Company	Trenz Electronic GmbH
PCN Number	PCN-20210510
Title	KK0803-03A to KK0803-04 Hardware Revision Change
Subject	Hardware Revision Change
Issue Date	2021-05-14

2.1 #1 Changed milled height profile.

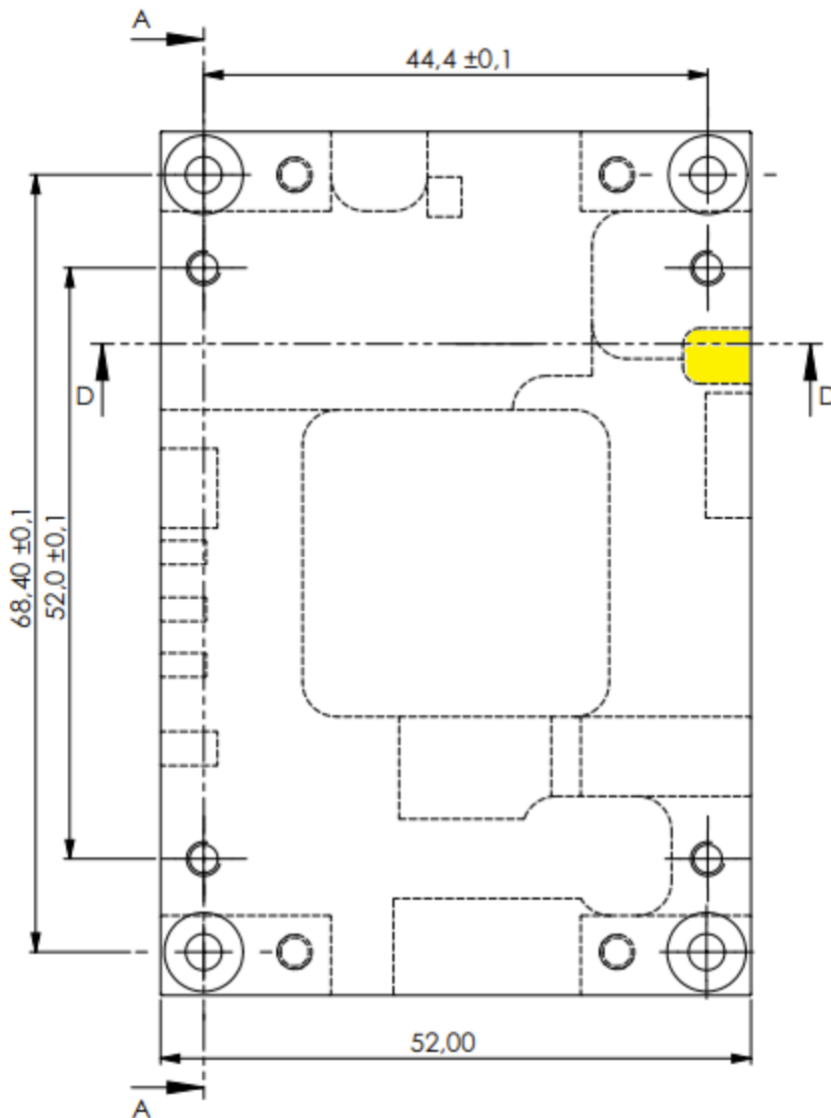
Type: Hardware change

Reason: Revision 04 of TE0803 has different skyline and is therefore mechanical not compatible with KK0803-03A.

Models with the feature marked in yellow are revision 04. Heatspreader without that feature are of older revision and not compatible to TE0803-04.

Impact: New heat spreader is compatible with TE0803-04, and also backwards compatible to older versions of TE0803.
